Mr. Harry Tsomides  
NCDEQ – Division of Mitigation Services  
5 Ravencroft Dr., Suite 102  
Asheville, NC 28801

December 21, 2021

Ecosystem Planning and Restoration (EPR) has reviewed the comments on the Draft MY2 Monitoring Report provided December 7, 2021. The comments have been addressed as described below and the Final MY2 Report and electronic deliverables have been revised in response to this review.

**Monitoring Year 2 Report**  
**Final**  
**Meadow Brook Stream Restoration Project**  
**Yadkin County, North Carolina**  
**Yadkin River Basin, Hydrologic Unit Code (HUC) 03040101**

**MEADOW BROOK STREAM MITIGATION PROJECT**  
 CURRENT CONDITION PLAN VIEW: OVERVIEW  
 MY2: 2021

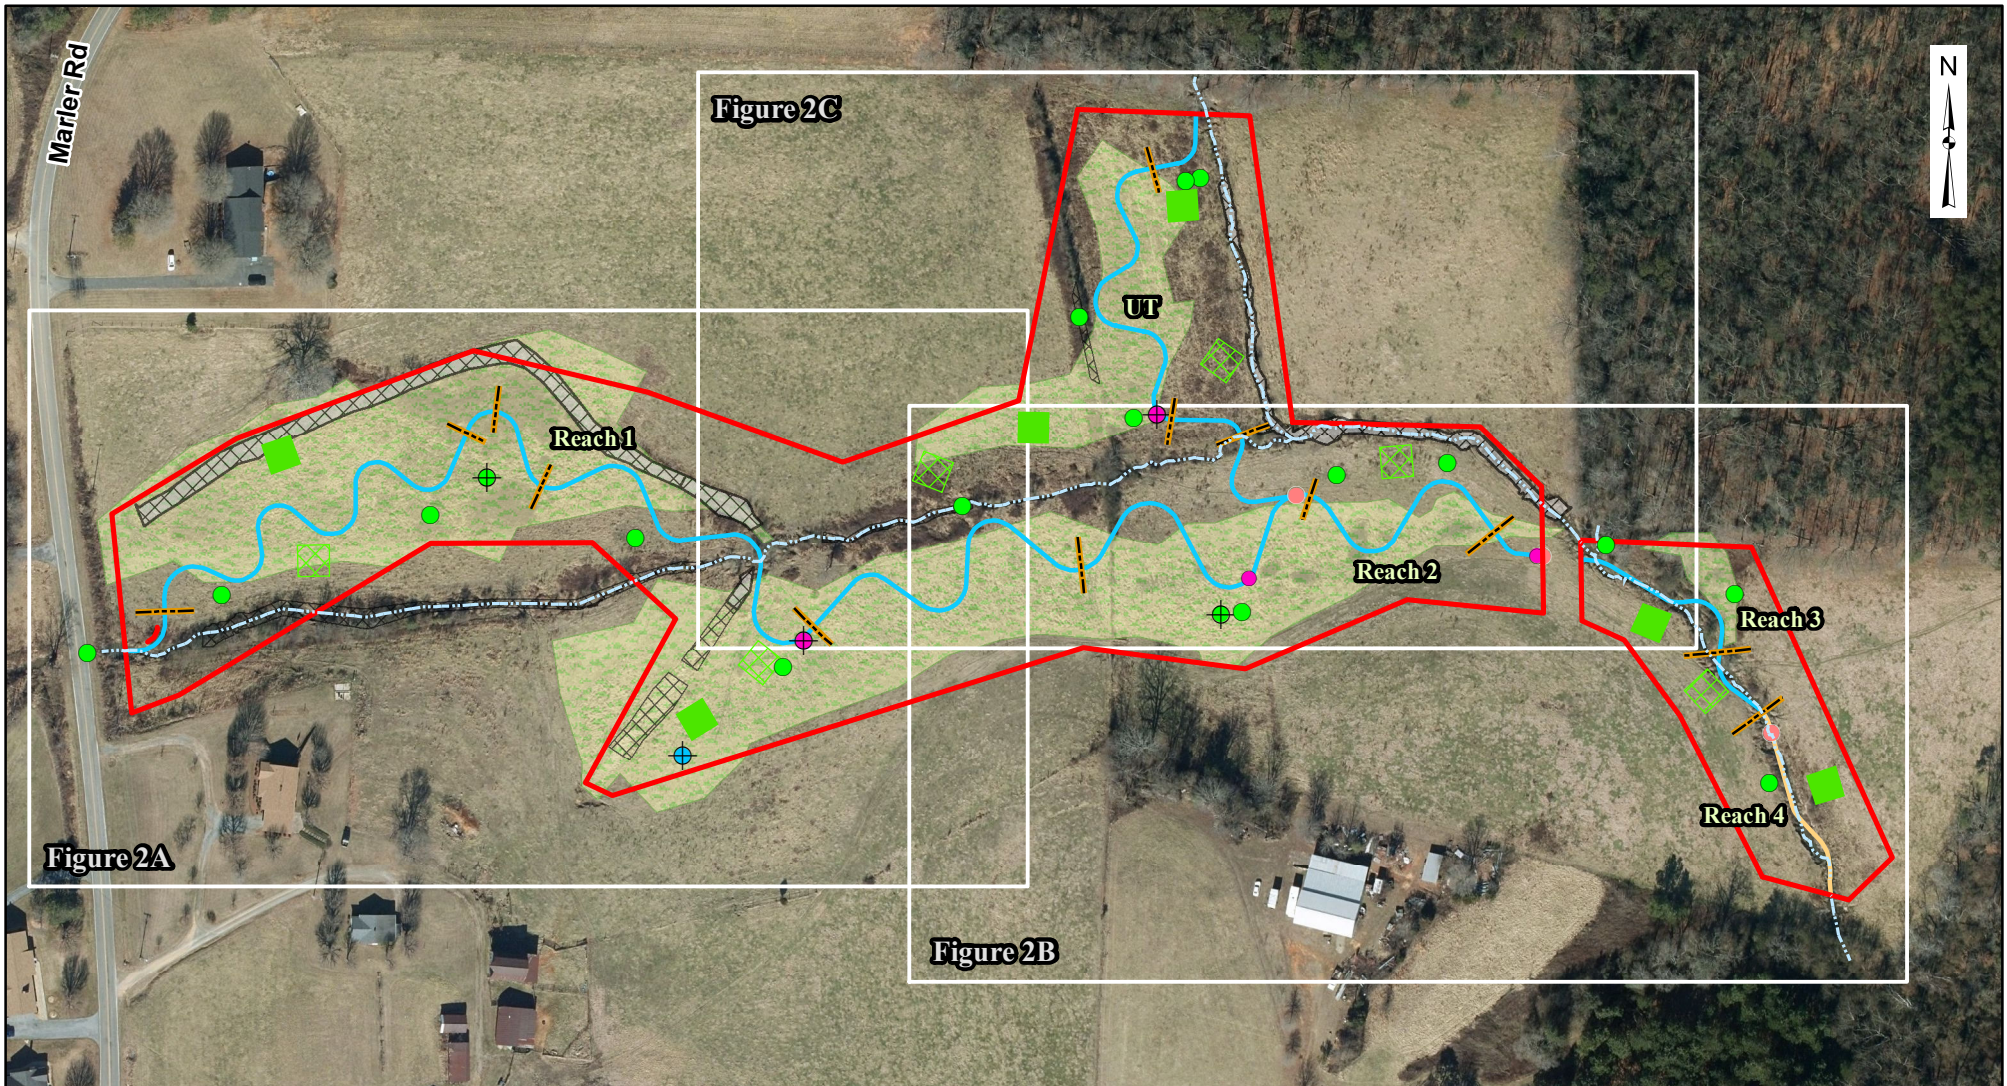
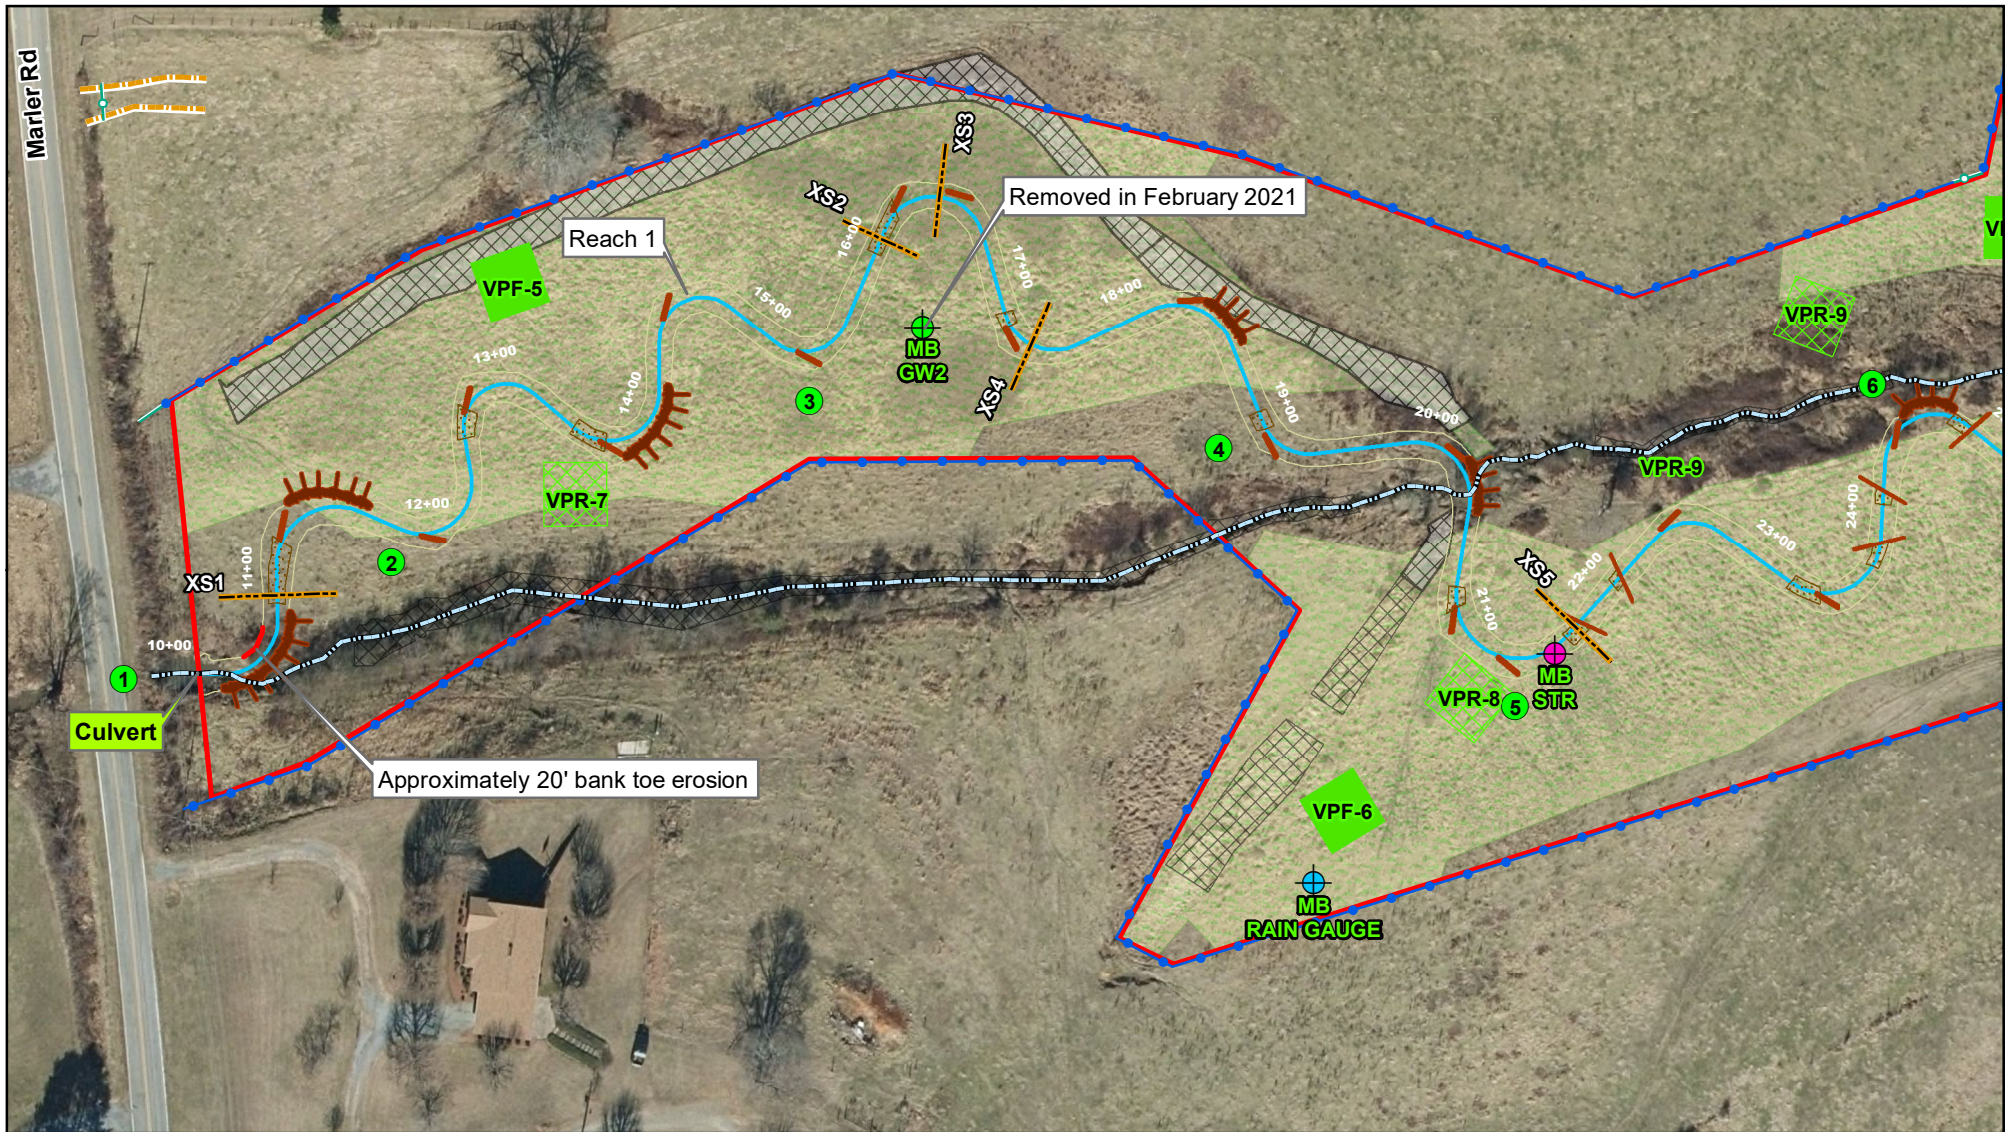
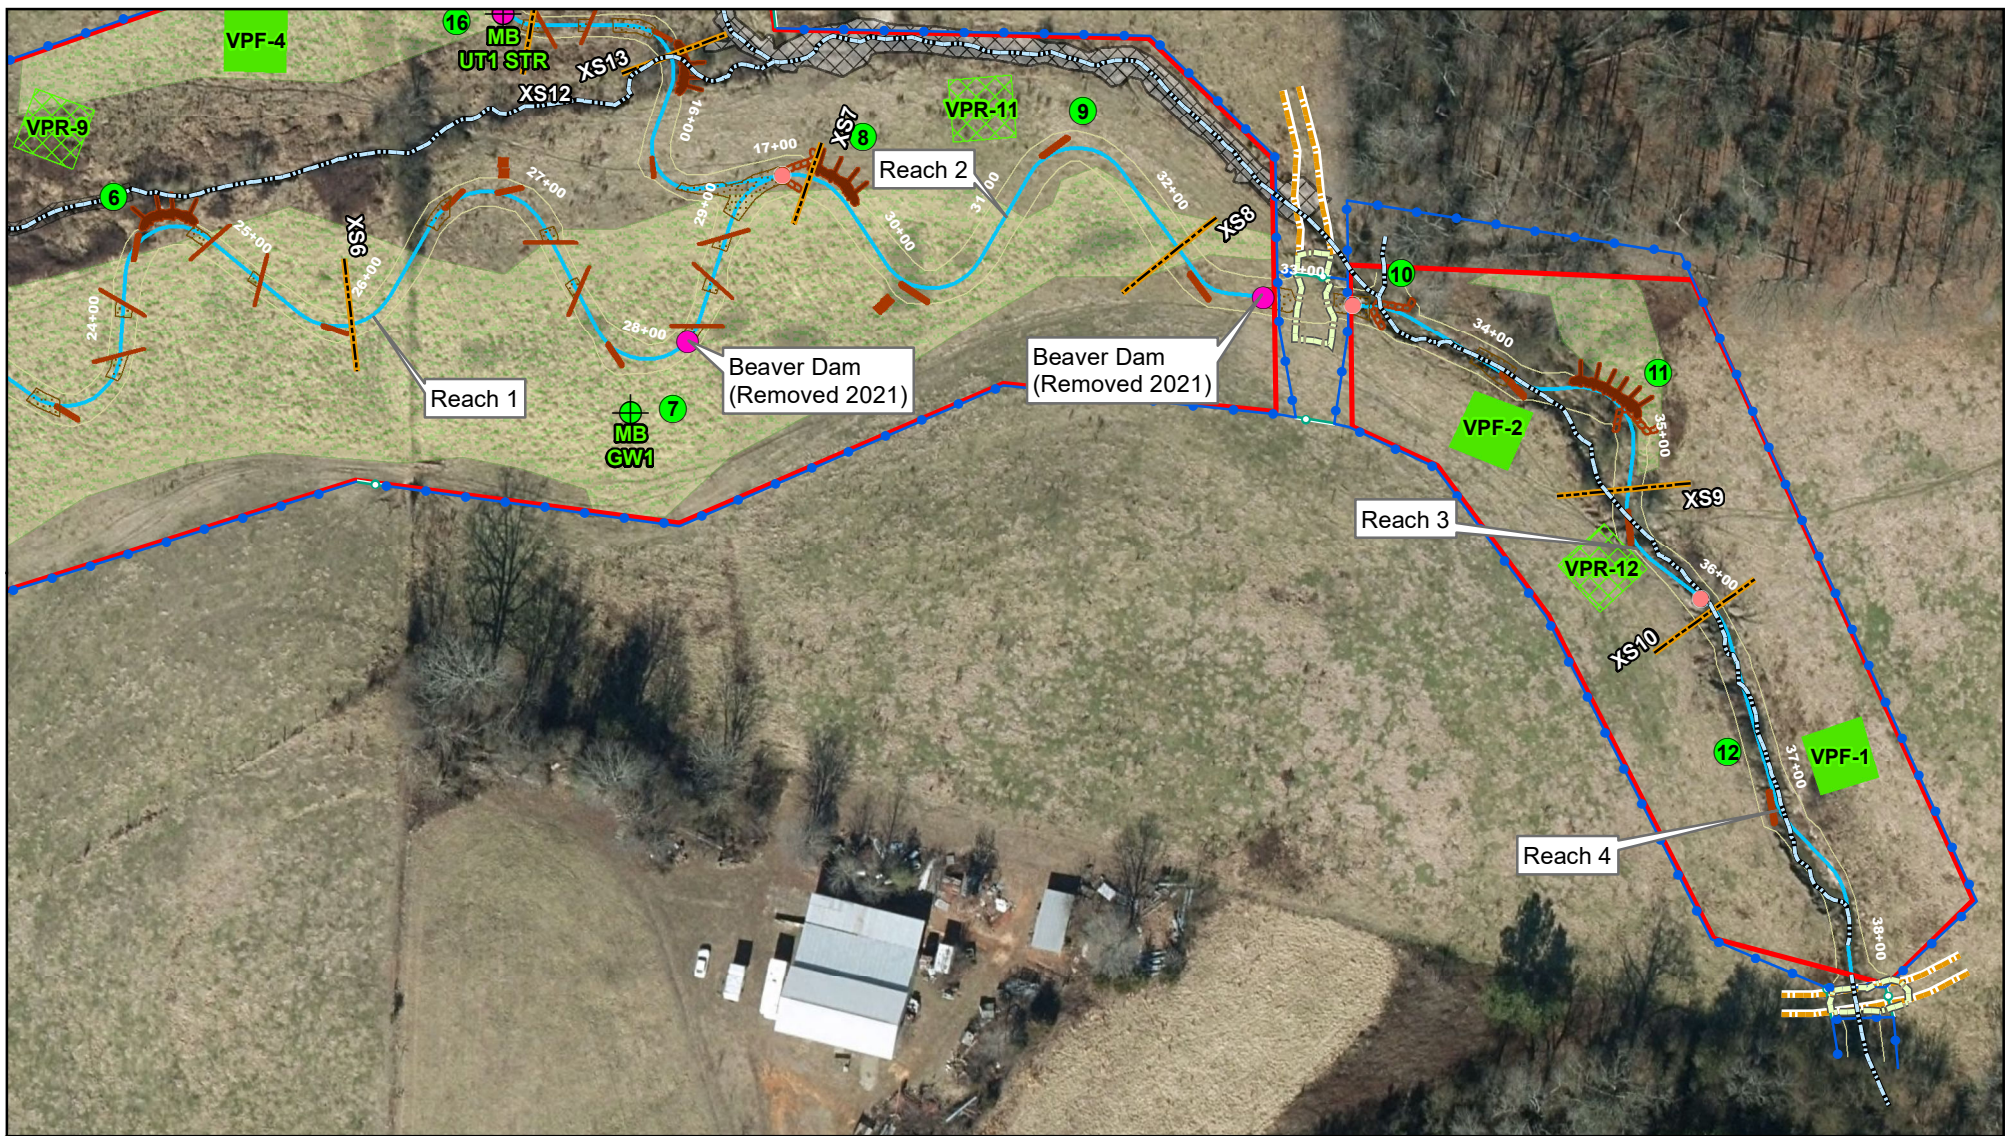
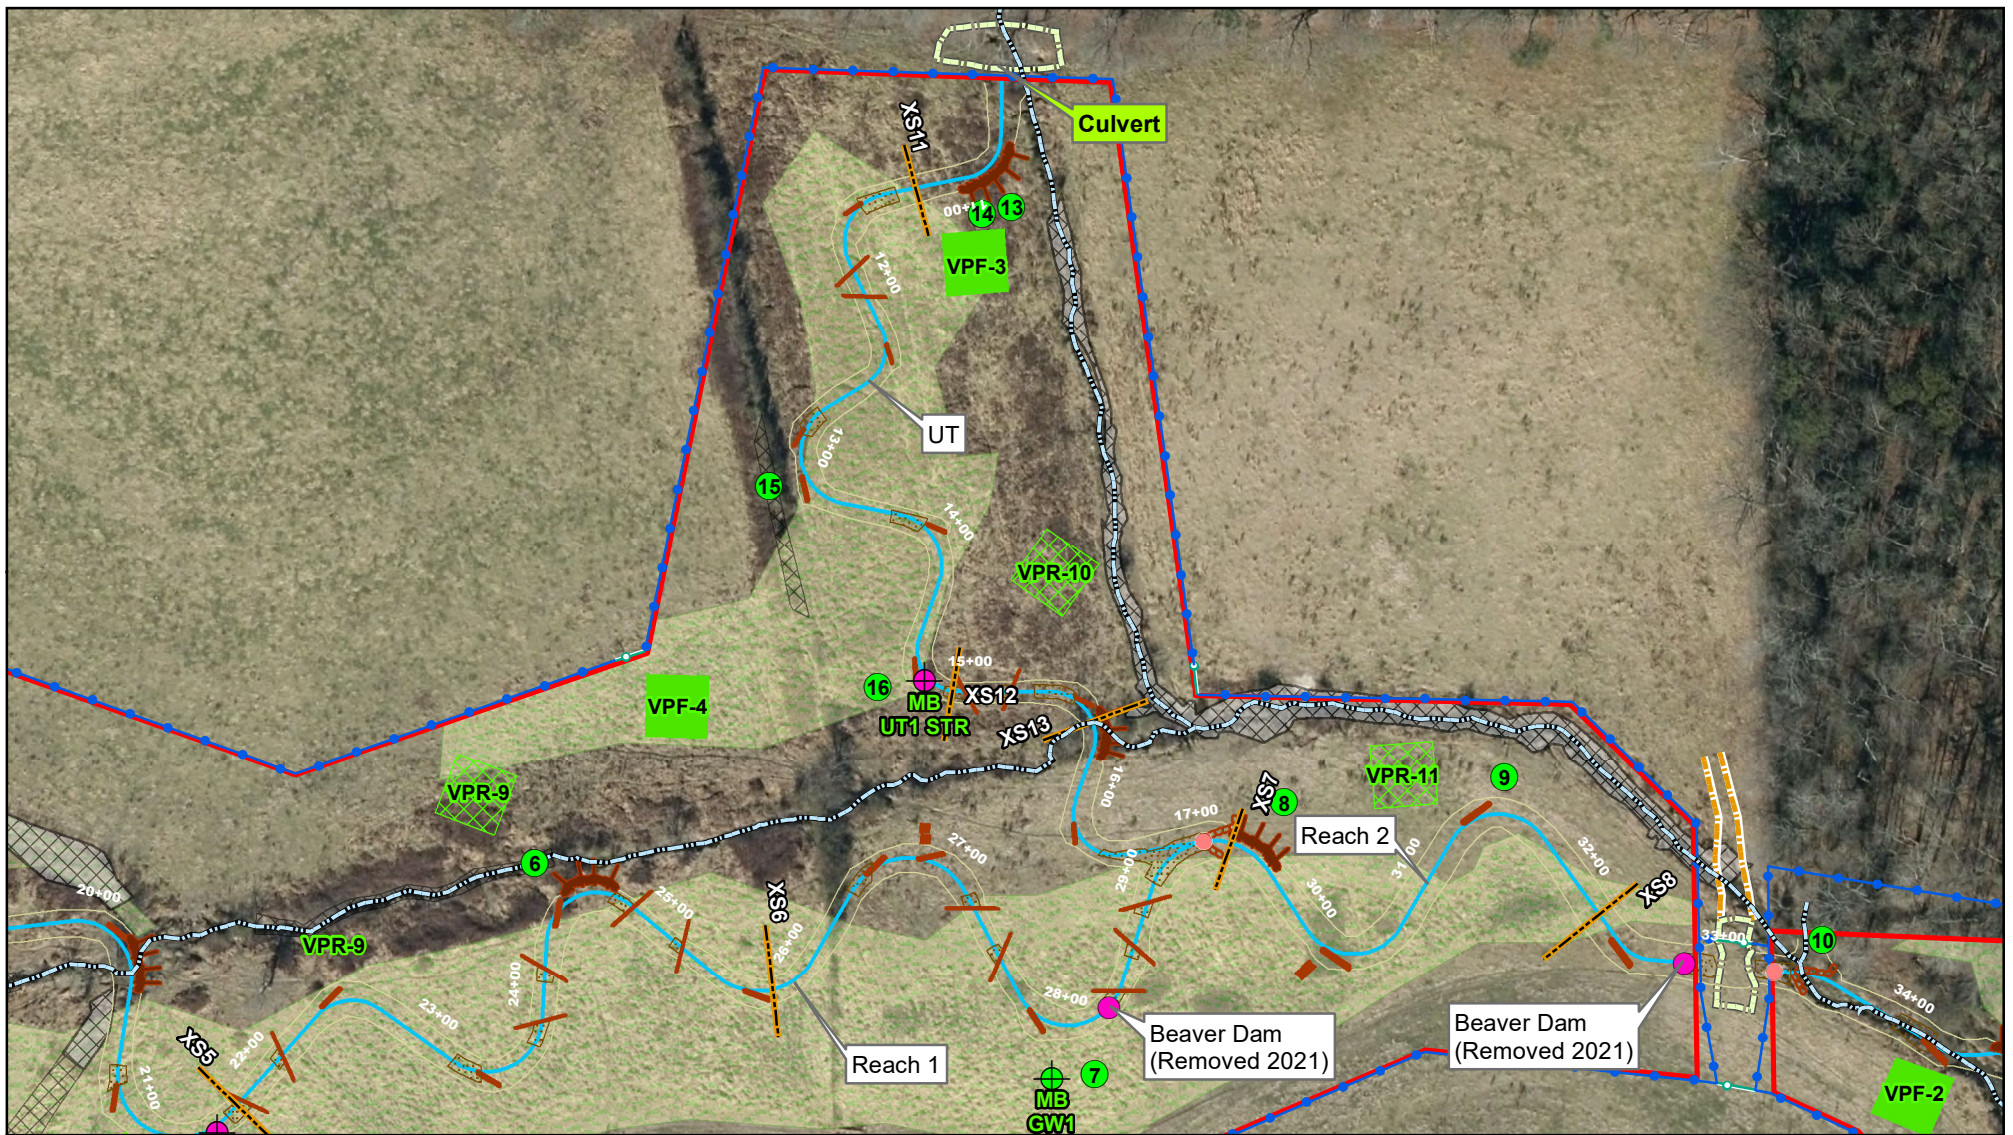
- *Please submit point features representing where beaver dams had existed.*
  - **A shapefile showing the locations of the two beaver dams that were removed in 2021 has been added to the electronic submittal. The points have been added to the CCPV.**

- *Please submit a feature depicting the 20ft of Toe Erosion along Meadow Brook Reach 1 and display this feature in the CCPV.*
  - **A shapefile showing the 20 ft. of toe erosion along Meadow Brook Reach 1 has been added to the electronic submittal. The polyline feature has been added to the CCPV.**
